Service Bulletin

SEB93-15

ELECTRICAL PUSH-PULL SWITCH REPLACEMENT

TITLE PUSH-PULL SWITCH REPLACEMENT - T41A

Figure 1. Push-Pull Switch Replacement (Sheet 2)

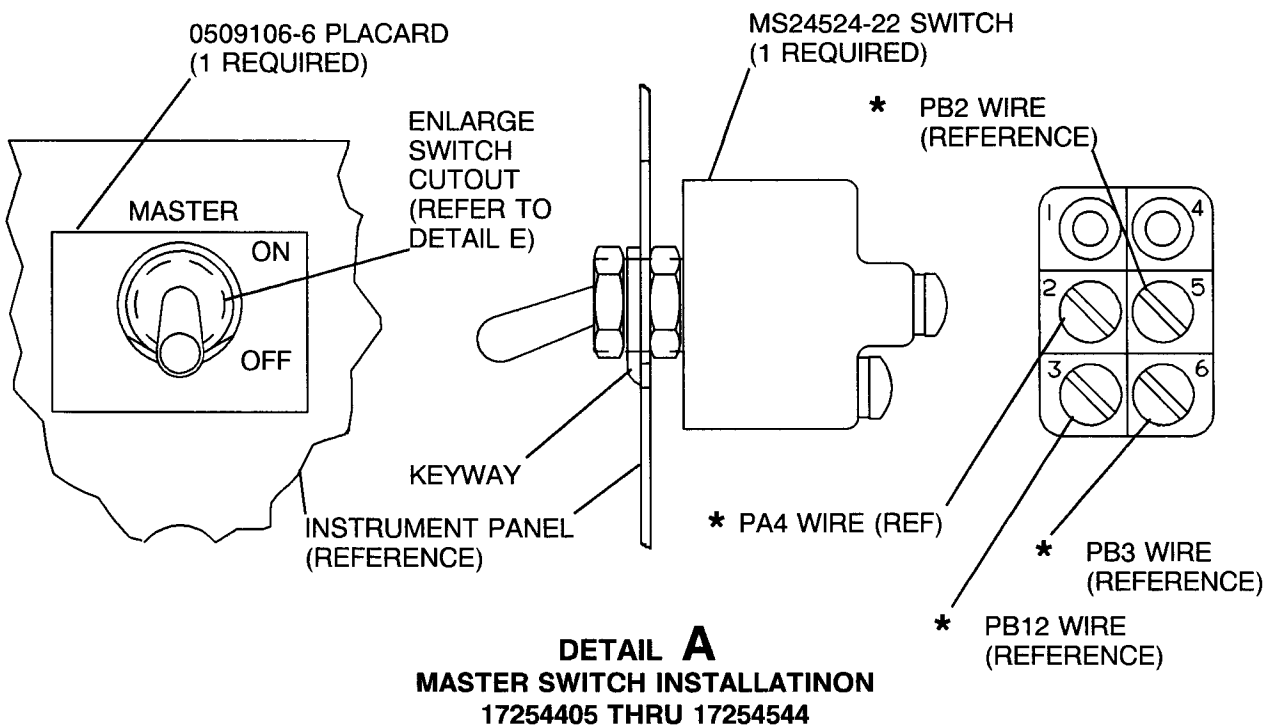
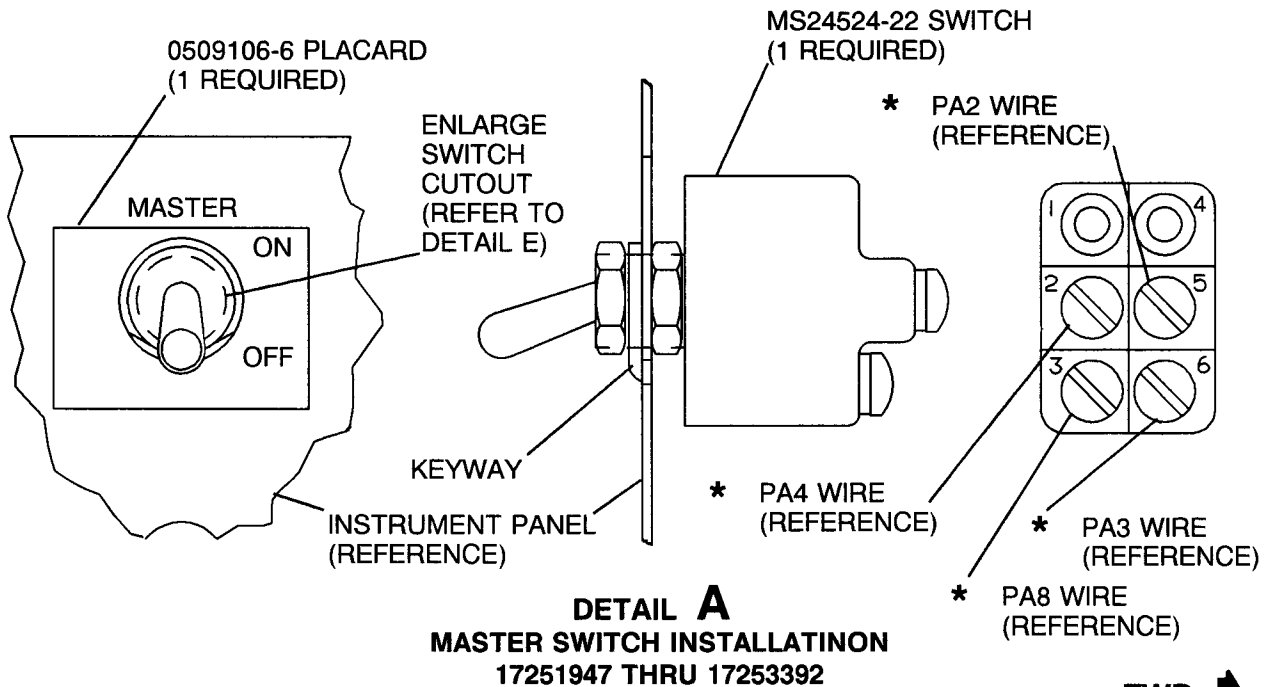
- B. (Refer to Figure 1, Detail A, Sheets 2 and 3) Gain access and remove existing master switch from instrument panel. Disconnect wiring and remove and discard switch. Refer to applicable Detail A to match serial number of airplane.

- C. Remove existing S1367-1-8 terminals from the affected wires as shown. Install the new S1367-1-6 terminals on the affected wires.
 - D. (Refer to Figure 1, Detail E, Sheet 7) Enlarge existing cutout in the instrument panel where the old switch was removed per dimensions shown. Deburr and clean hole as required.

- E. (Refer to Figure 1, Details A, Sheets 2 & 3) Install 0509106-6 placard on instrument panel as shown. Heat applied to placard will aid in adhesion to panel cover.

DETAIL A
MASTER SWITCH
17256280 THRU 17256346

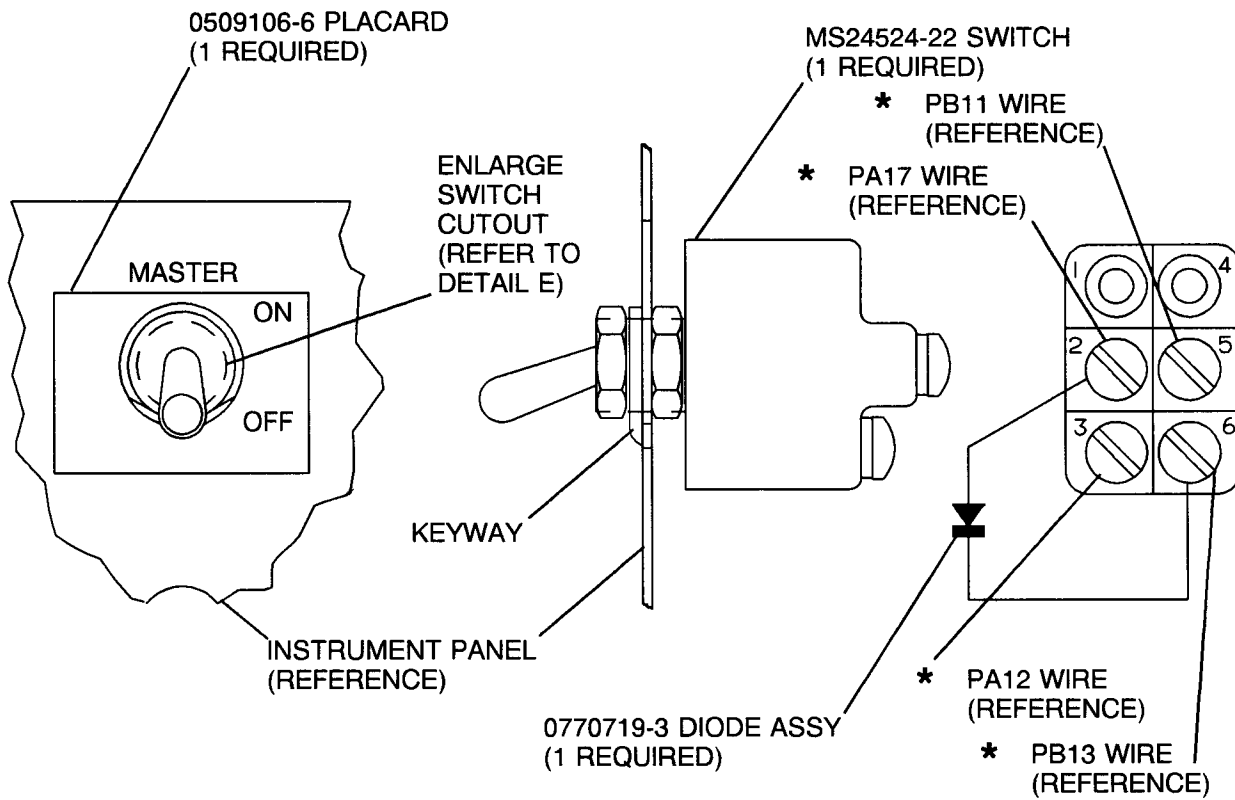
NOTE: For serials 17256280 thru 17256346 add the 0770719-3 diode assembly to the switch as shown in detail A, sheet 3. Verify the proper position of the anode.

Figure 1. Push-Pull Switch Replacement (Sheet 4)

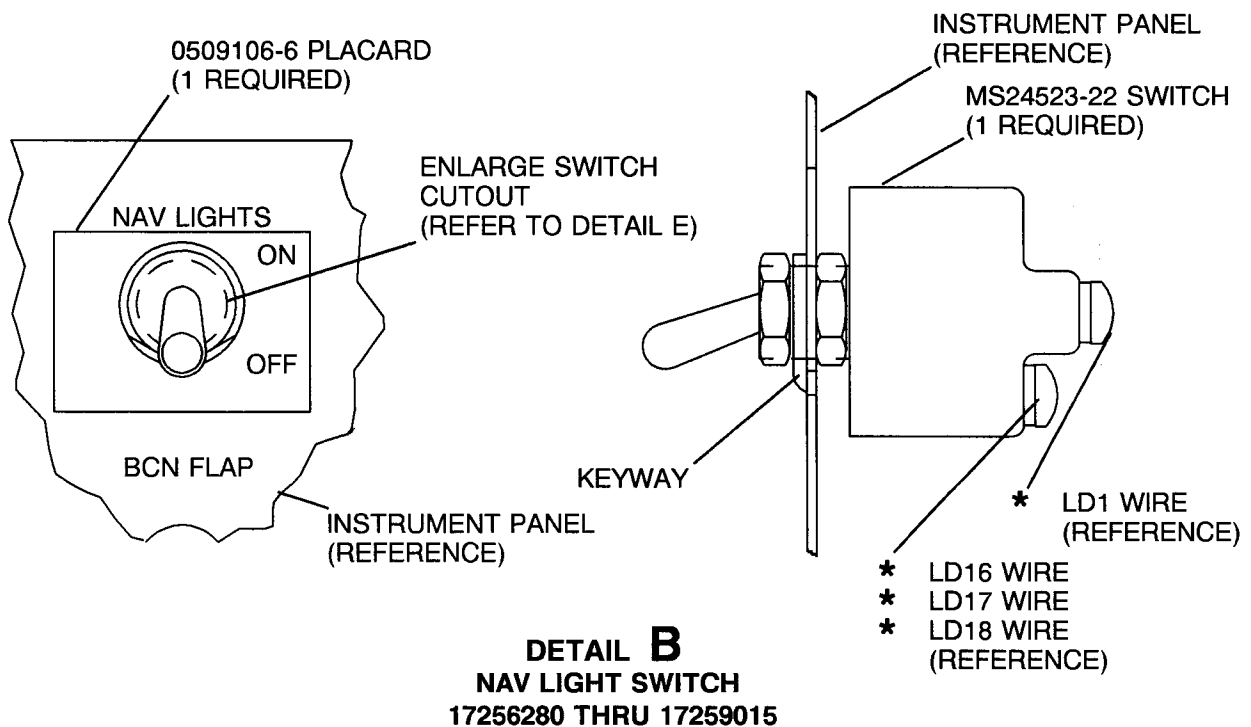
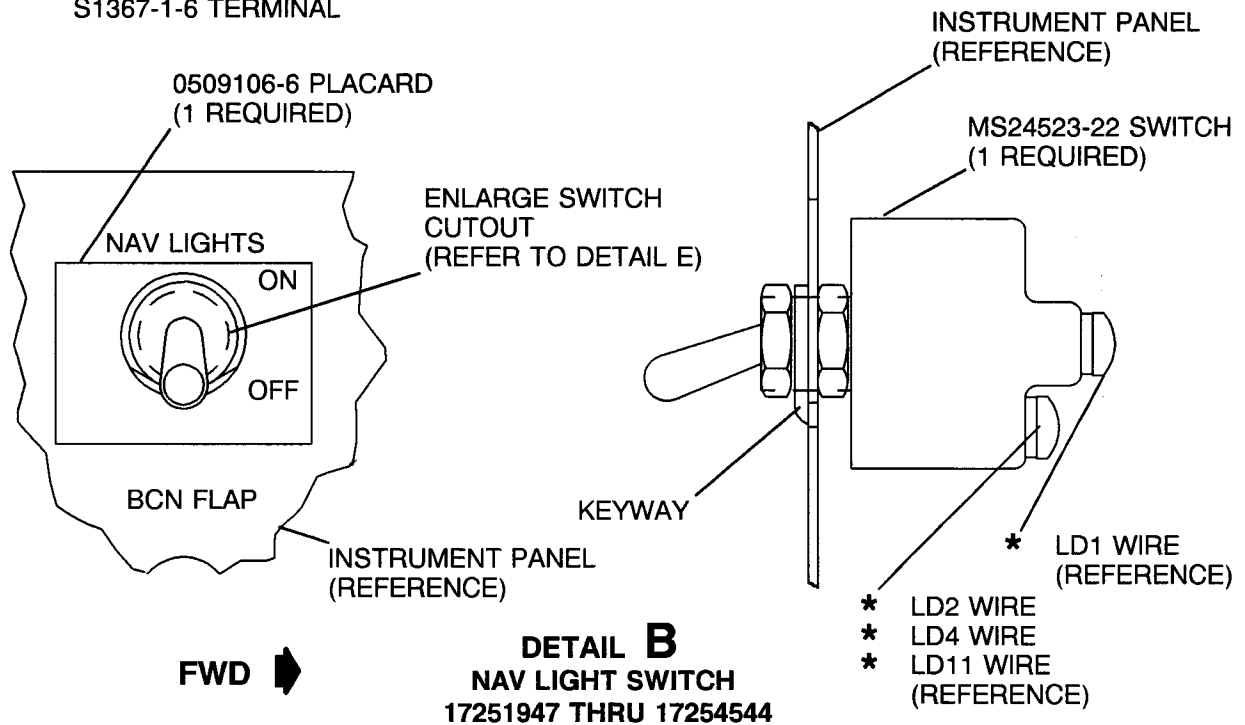
- B. (Refer to Figure 1, Details B, Sheet 4) Gain access and remove existing nav light switch from instrument panel. Disconnect wiring and remove and discard switch. Refer to applicable illustration to match serial number of airplane.

- E. (Refer to Figure 1, Details B, Sheet 4) Install 0509106-6 placard on instrument panel as shown. Heat applied to placard will aid in adhesion to panel cover.

Figure 1. Push-Pull Switch Replacement (Sheet 5)

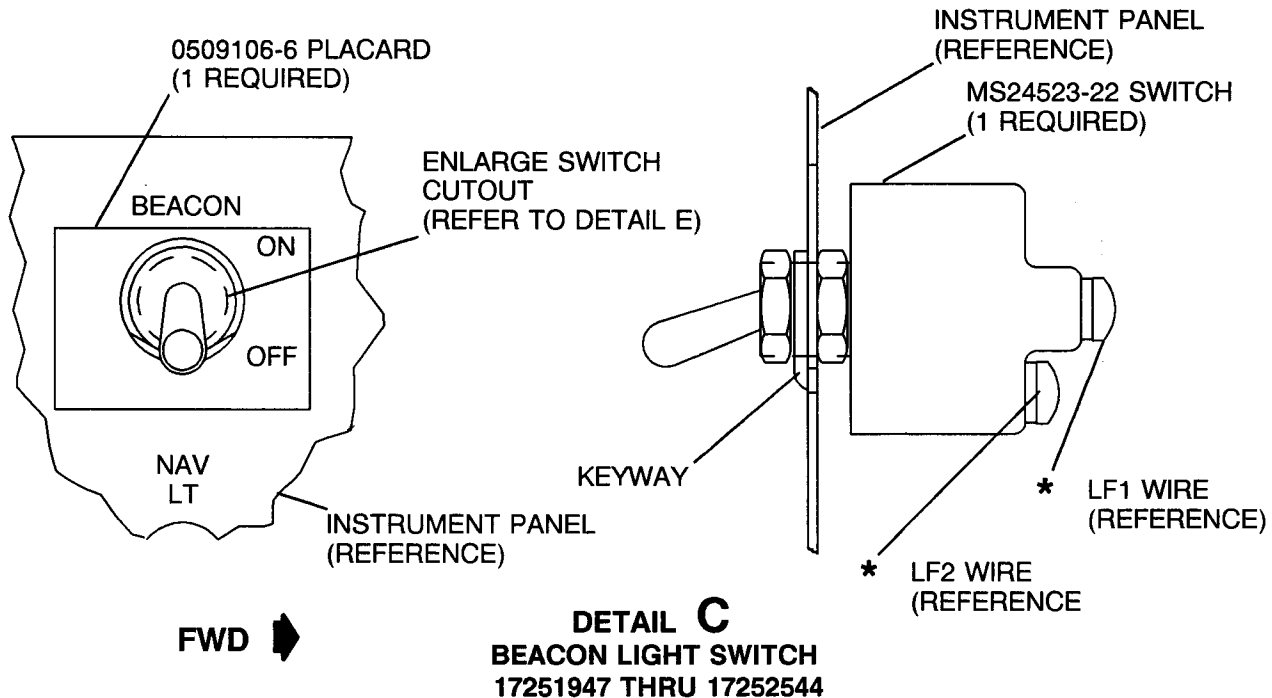
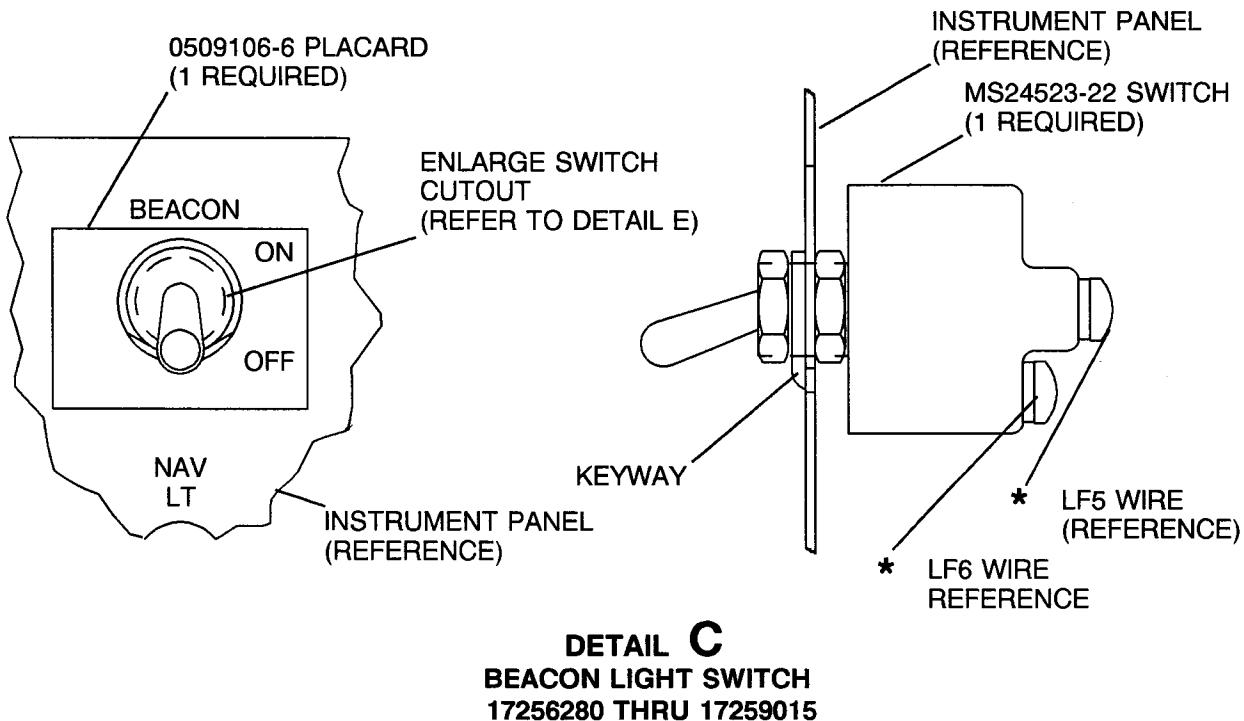
- B. (Refer to Figure 1, Details C, Sheet 5) Gain access and remove existing beacon light switch from instrument panel. Disconnect wiring and remove and discard switch. Refer to applicable illustration to match serial number of airplane.

- E. (Refer to Figure 1, Details C, Sheet 5 & 6) Install 0509106-6 placard on instrument panel as shown. Heat applied to placard will aid in adhesion to panel cover.

Figure 1. Push-Pull Switch Replacements (Sheet 6)

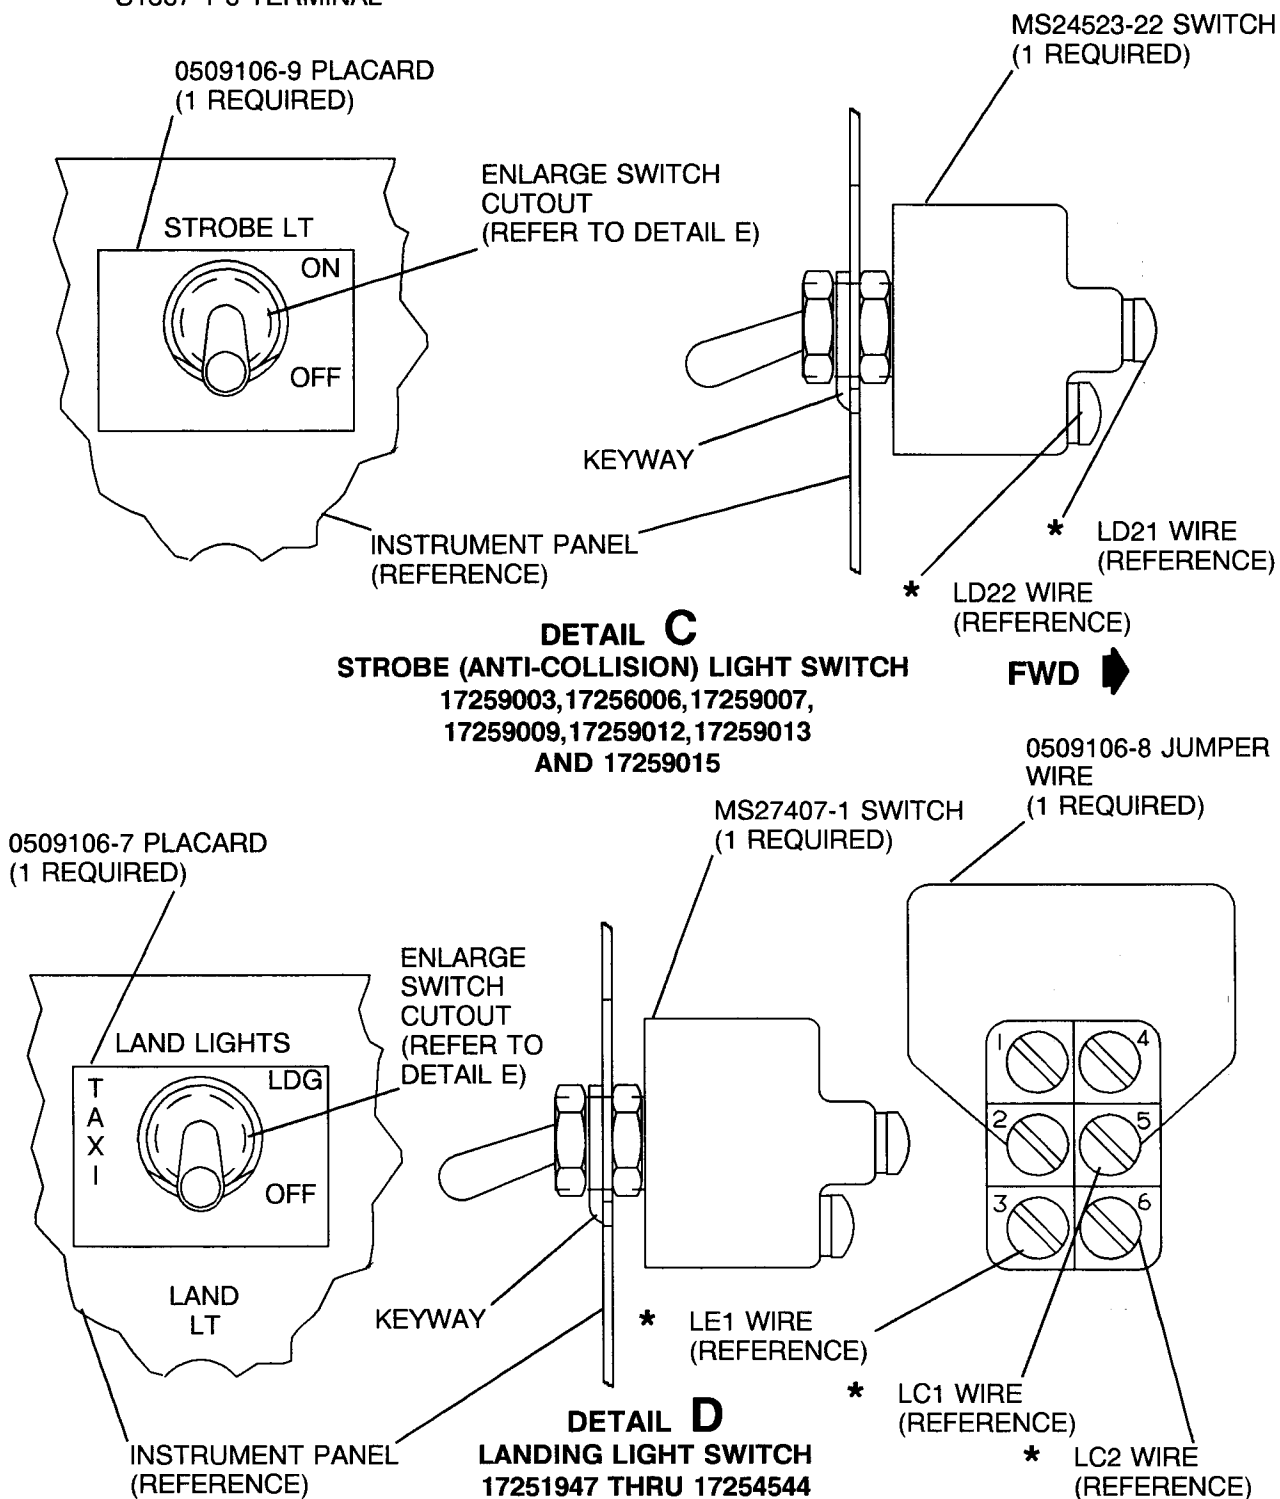
- B. (Refer to Figure 1, Details D, Sheet 6 & 7) Gain access and remove existing landing light switch from instrument panel. Disconnect wiring and remove and discard switch. Refer to applicable illustration to match serial number of airplane.

Figure 1. Push-Pull Switch Replacement (Sheet 7)

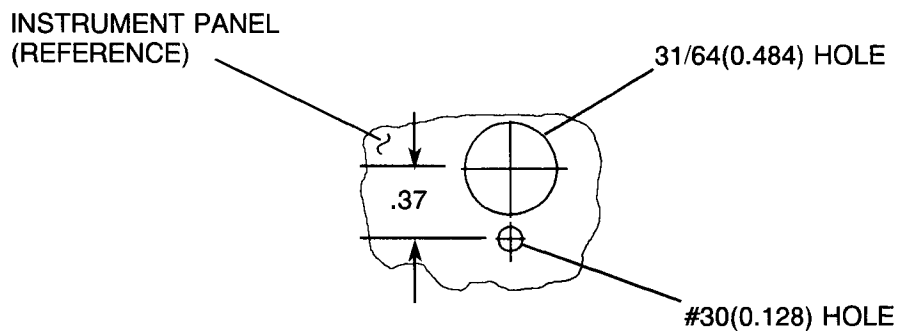
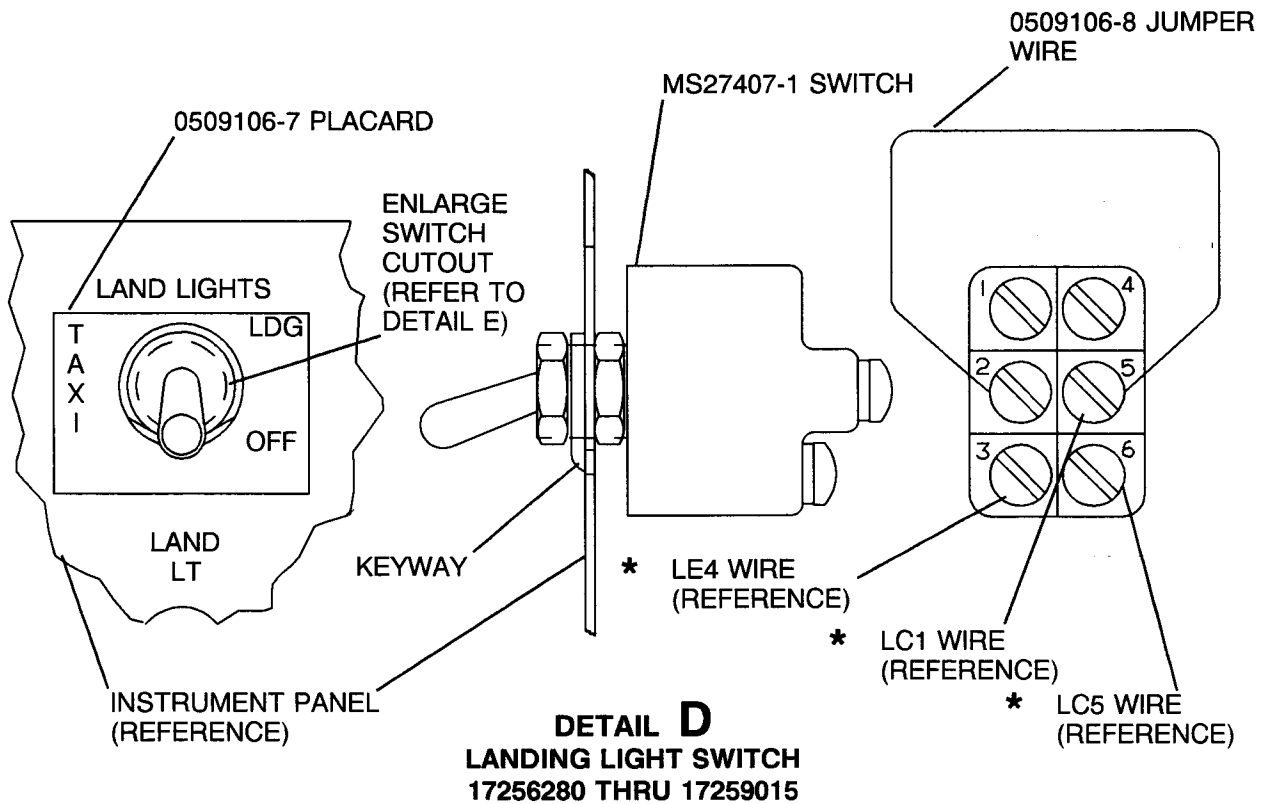
- C. Remove existing S1367-1-8 terminals from the affected wires as shown. Install the new S1367-1-6 terminals on the affected wires.
 - D. (Refer to Figure 1, Detail E, Sheet 7) Enlarge existing cutout in instrument panel where switch was removed per dimensions shown. Deburr and clean hole as required.

- E. (Refer to Figure 1, Detail D, Sheet 7) Install 0509106-7 placard on instrument panel as shown. Heat applied to placard will aid in adhesion to panel cover.
